City of
Peterborough

Committee of Adjustment Hearing Date: May 3, 2016

Staff Comments Regarding: Files A16/16, A17/16, A18/16, A19/16, A20/16, and A21/16

EXHIBIT **A**
SHEET **1** OF **1**

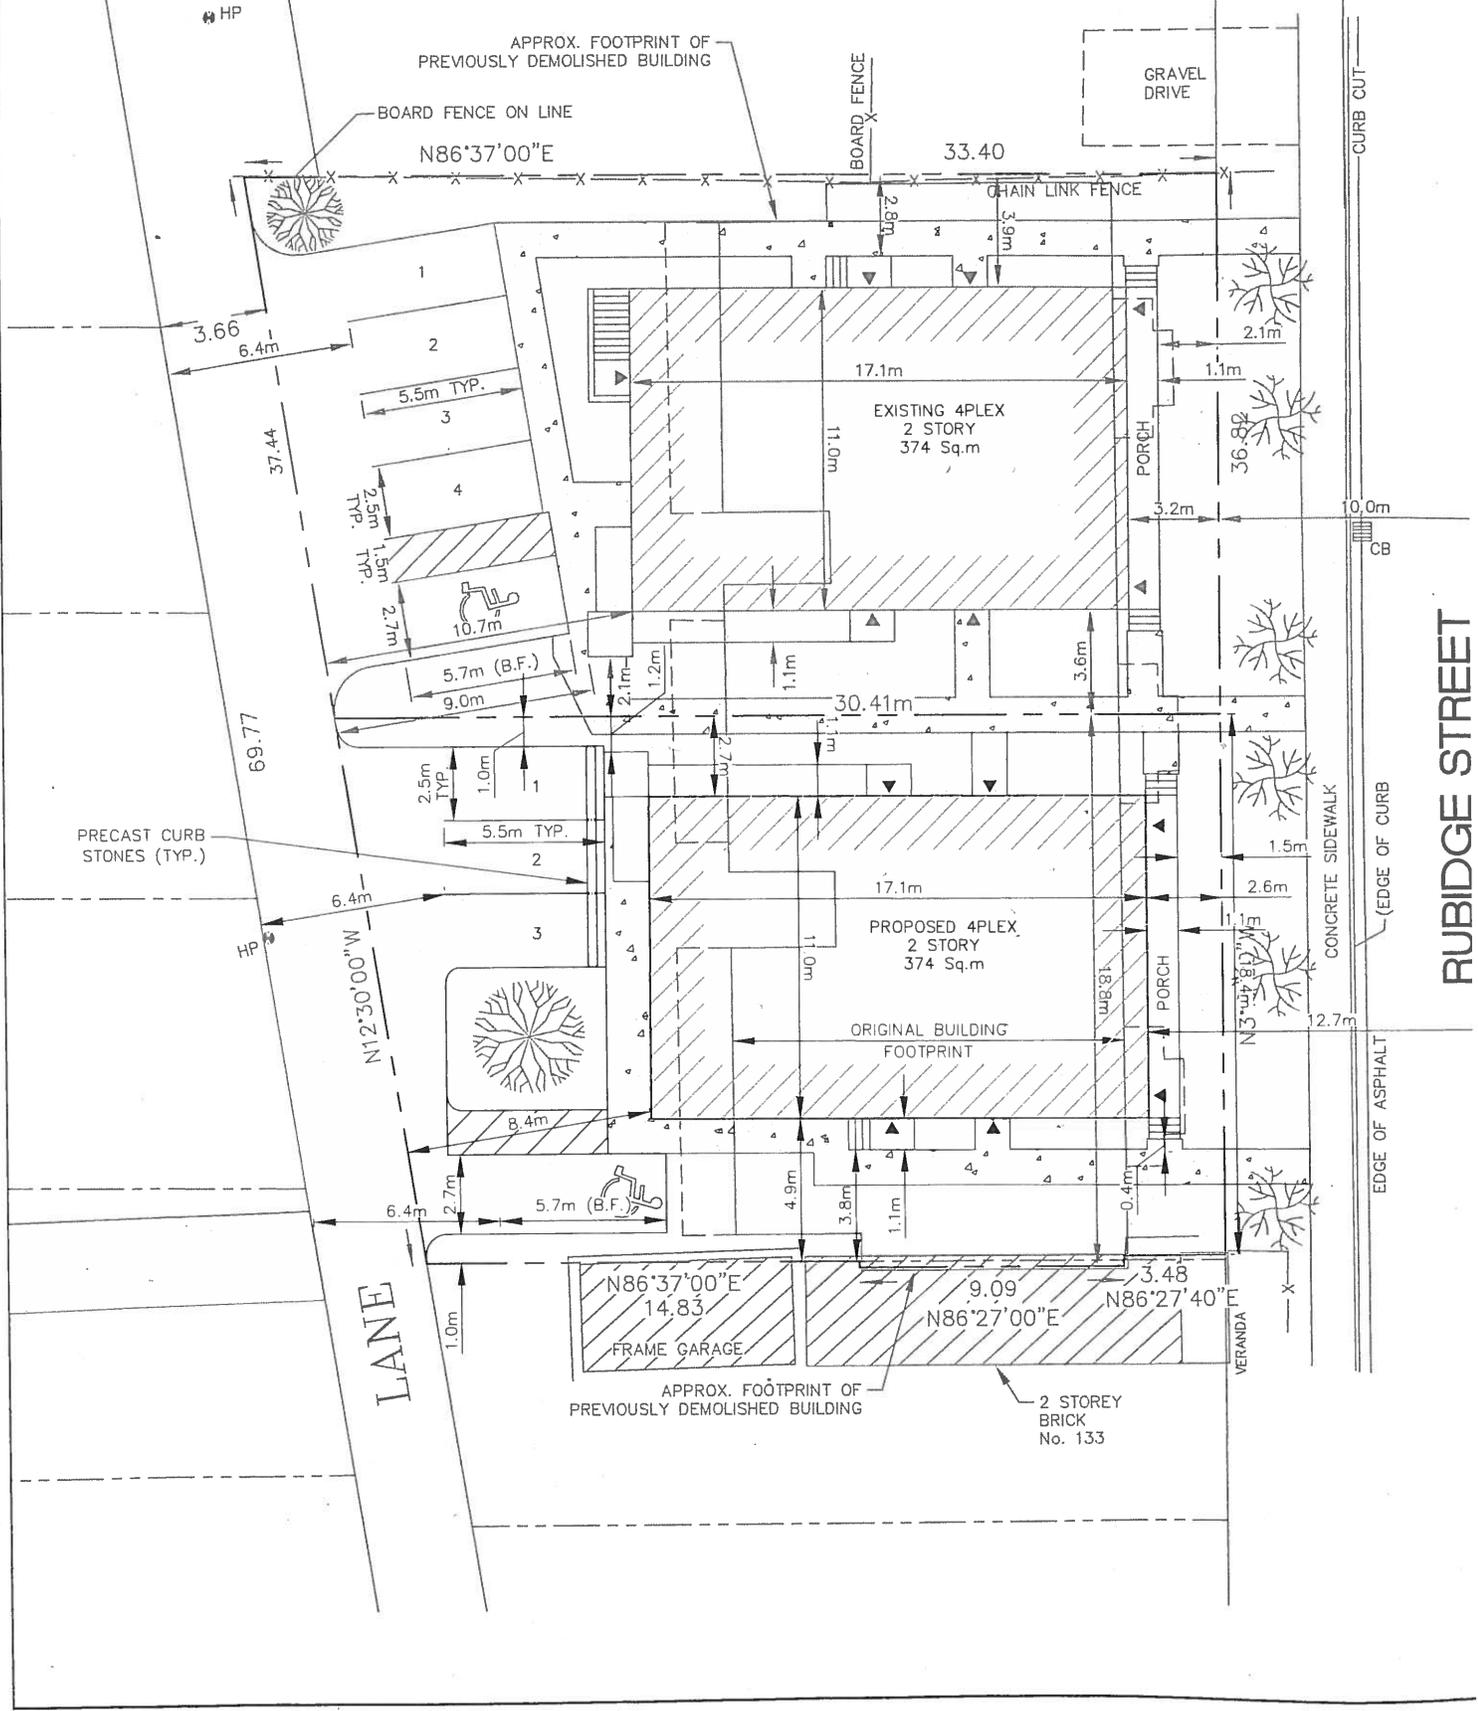
Referring to the Plan attached as Exhibit A, the following variances are now requested to the zoning and parking regulations that apply to the south portion of the property:

- i) reduce the minimum required lot area per dwelling unit from 185 sq metres to 134 sq metres,
- ii) reduce the minimum building setback from the north side lot line from 3 metres to 2.1 metres for the main building and to 1.2 metres for a porch, open decks and platforms,
- iii) reduce the minimum building setback from the rear lot line from 9 metres to 8.4 metres,
- iv) increase the maximum building coverage from 30% to 42%,
- v) reduce the minimum required number of motor vehicle parking spaces from 6 to 4,
- vi) reduce the minimum dimensions of a parking space from 2.7 metres by 5.7 metres to 2.5 metres by 5.5 metres, and
- vii) reduce the minimum building setback from the centre line of Rubidge Street from 16 metres to 12.7 metres.

Staff commented on the building setback regarding the north property and is of the same opinion regarding redevelopment of the south property. Considering the building form and location of development on adjacent lots, Staff would consider the setback of the building on the property that was once established to be appropriate. A survey of the former row house that existed on the property is attached as Exhibit B for reference. The survey illustrates the building that was located approximately 3.3 metres (11 ft) from the street line or 13.3 metres from the centreline of Rubidge Street.

Considering that Rubidge Street is an arterial street, the intended setback of modern day zoning regulations regarding development in relation to an arterial street, and the setback of buildings established on adjacent properties in the vicinity, Staff is of the opinion that the setback of no less than 13 metres from the centre line of Rubidge Street be granted that would allow the structure to be 3.3 metres from the street line. While the variance was requested to 12.7 metres for the dwelling, the Committee should note that there was no variance requested or notice provided regarding any variance to allow the verandah extending in front of the building as illustrated on the plan.

Considering the variances requested to setbacks of the building from the rear lot line, and for porches, open decks and platforms from the north lot line together with an increase in lot coverage from 30% to 42%, it would seem the proposal is an overdevelopment of the site. The site relies on a shared laneway to access parking on the property that may meet the lot coverage standard, however the coverage of the lot by building leaves little space on site for landscaped amenity space, snow storage and permeable surface to handle storm water run off. Considering the dimensions on the drawing provided, the variances requested appear to be a randomly requested. The main building appears to be 2.7 metres from the north lot line variance so the variance requested to 2.1 m cannot be justified. The covered verandah on the side of the building is 1.6 metres from the north lot line and only the open platform appears to be 1.2 metres from the north lot line. As stated, no variance was requested for the setback of the front verandah from the street line.

While the variance to the size of the parking spaces associated with residential development may be appropriate, the variance to reduce the parking required to one space per unit may not be in that there is no opportunity for visitor parking on the site and restricted (1 hour) parking only on the east side of Rubidge Street.

Should the Committee choose to grant any of the variances, considering the latest concept site plan proposed, Staff would recommend that the decision be subject to site plan agreement to address parking, snow storage, landscaping and walkways shown on the plan to straddle the proposed lot lines, considering the severance.

SITE PLAN

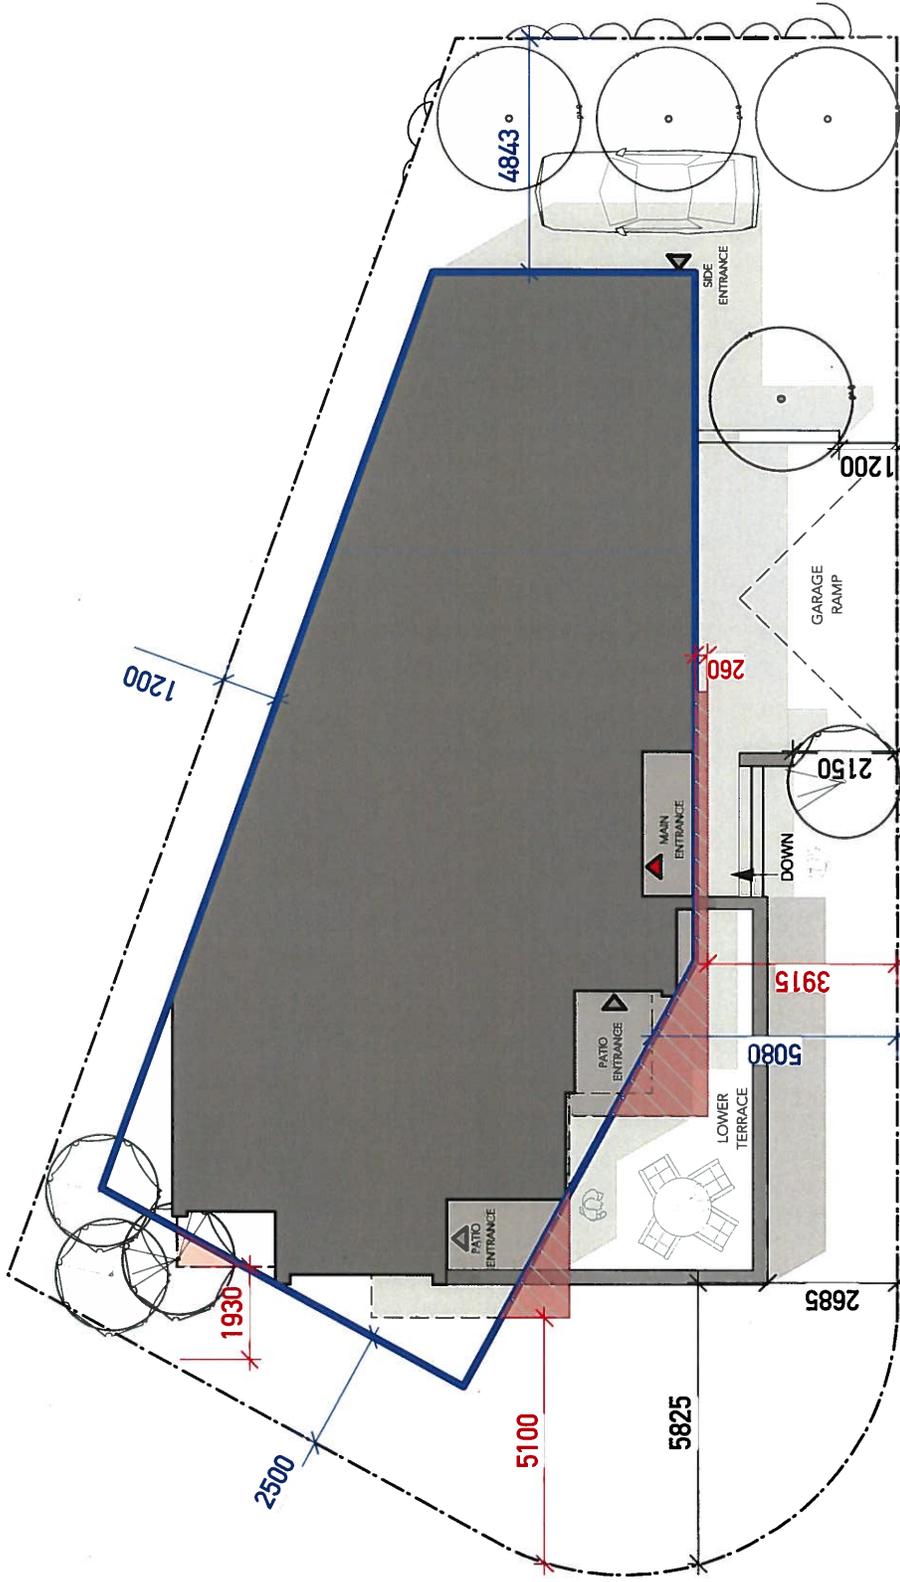
The subject property is located at 63 Edgewater Boulevard at the corner of Edgewater Boulevard and Bruce Street, a high profile location on Burnham Point. The owner would like to establish a new building on the property as illustrated on the plans attached as Exhibit F. The following variances to the standard building setbacks from Edgewater Boulevard and Bruce Street to allow the new building's setbacks to be similar to those of existing buildings on adjacent properties:

- i) reduce the minimum building setback from Edgewater Boulevard from 6 metres to 1.8 metres for a corner of the building,
- ii) reduce the minimum building setback from Bruce Street from 6 metres to 4.1 metres for the building and 3.915 metres for projected edges of the terrace, and
- iii) reduce the minimum building setback from Bruce Street from 6 metres to 2.6 metres for a retaining wall associated with a sunken terrace and to 2.1 metres and 1.2 metres in relation to retaining wall associated with the pedestrian entrance and driveway.

Referring to the Plans attached as Exhibit F, Staff considered the sight lines of other dwellings in the vicinity relative to the proposed setbacks. It should be noted that the building on the adjacent property at 61 Edgewater Boulevard has a similar setback, however, the setback is to an open verandah on the main level. The main building is actually set back 5.62 metres from the streetline. The proposed main building would project a further 3.1 metres out toward Edgewater Boulevard with a wider higher building massing of a one and a half storey building with a greater width in relation to the street line. Staff is of the opinion that the variance requested to the setback from Edgewater boulevard for the proposed footprint compared to the footprint of the existing building is not minor.

Considering the dwelling at 9 Bruce Street, the variances relative to Bruce Street will result in a larger building with a similar setback that will extend a building massing into the street setback that will cut down the sight lines. Once again, the result of the variances extending a continuous building massing in relation Bruce Street may not be considered minor.

Staff received a response from Peterborough Utilities regarding the location of water service very close to the lot line and Staff cannot support a variance that would allow any structure within 2.5 metres of the lot line. Staff cannot support the variances requested to the retaining wall structures associated with the entrance to the garage to any less than 2.5 metres from the street line.

Staff noted the plan illustrates the image of a motor vehicle parked to the north end of the property. A second curb cut in addition to the proposed 6 metre wide entrance to the driveway would not be permitted and, considering the grades of the property in relation to adjacent properties, it may be prudent to create and maintain a permeable surface in the form of soft landscaping to the north end of the property for storm water management purposes.

Should the Committee choose to approve any of the variances, site plan approval should be a condition requiring specifically, a storm water management plan, re-instatement of the barrier curb at the north end of the lot prior to establishing a curb cut for a new driveway and a landscaping plan requiring soft landscaping at the north end of the property that may be integral to the storm water management plan for the property to ensure adjacent properties are not affected either by overland flow or subsurface transmission of water.

EXHIBIT F
SHEET 2 OF 3

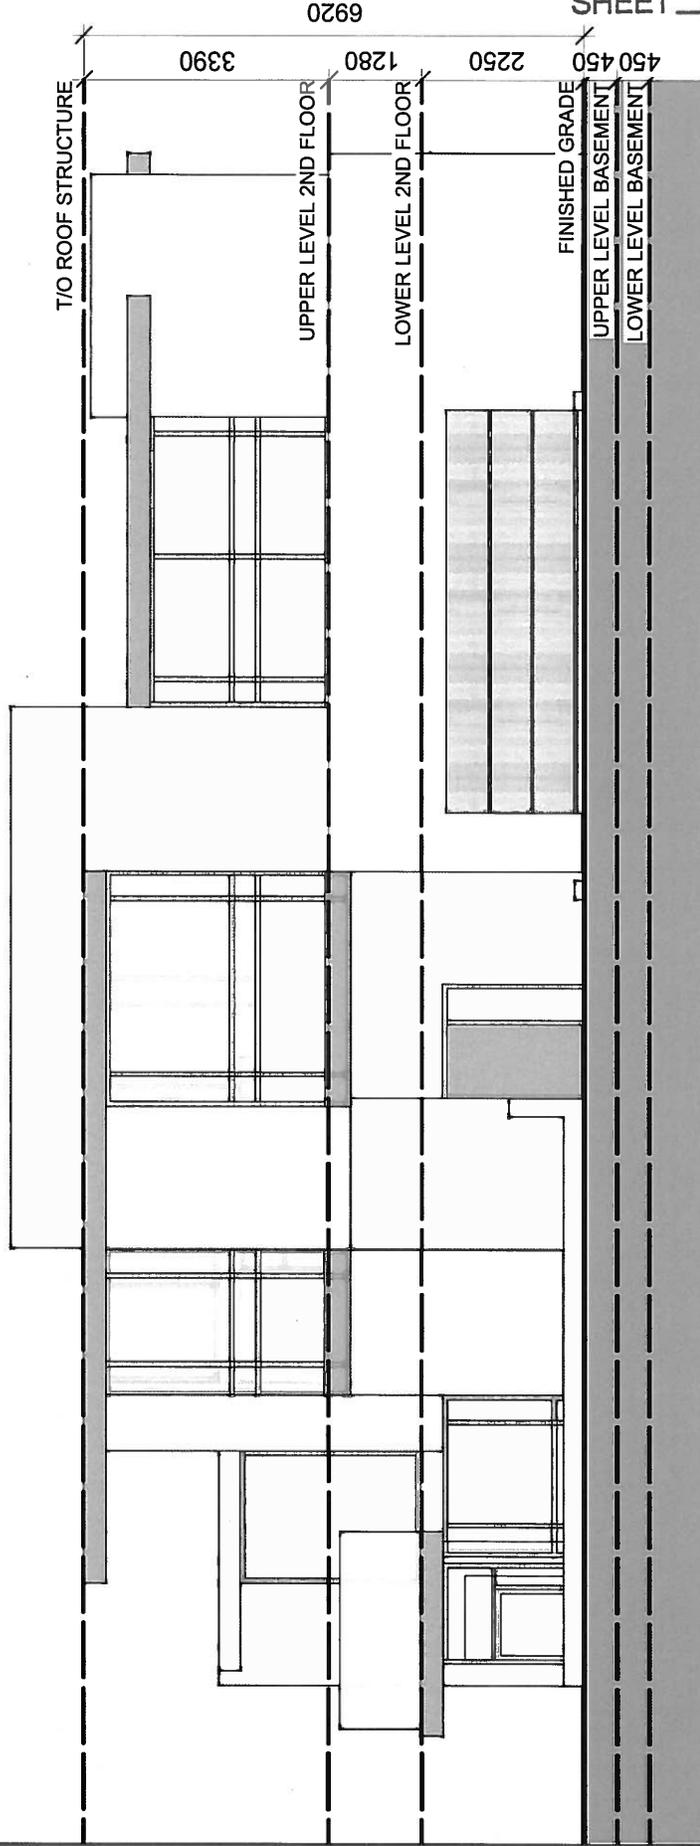
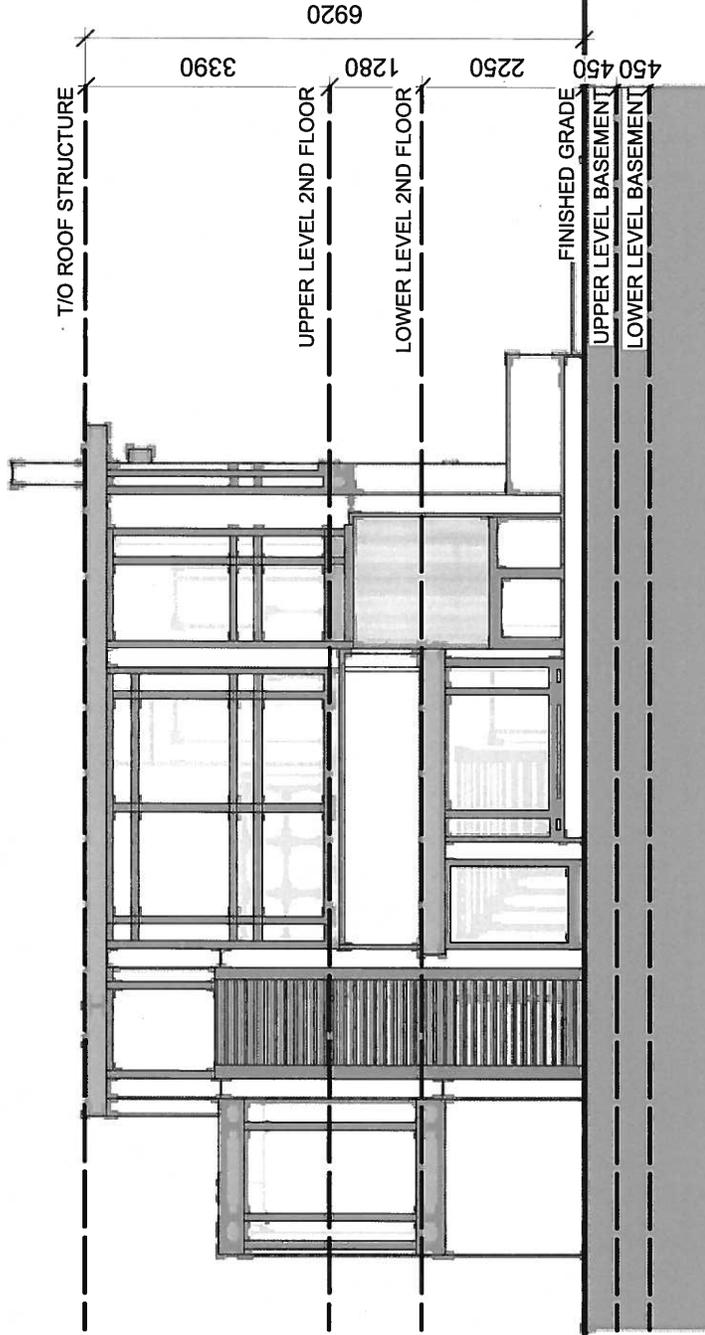
One of the four tests of a minor variance is a determination of whether the variance is minor or not. The variances as described appear numerically substantial but notwithstanding the required setback of 6 metres from the street line, the setback of buildings on adjacent properties are setback 4 metres to 5 metres to the building face and as little as 3.2 metres to an open verandah. What should also be considered is the accumulated effect of building massing relative to the street line and the space between buildings on properties. Although the existing building on the property is a storey and a half, the architect has deigned a building that will be set into the ground in attempt to maintain the lower height of the existing storey and a half building, mind you, with a flat roof.
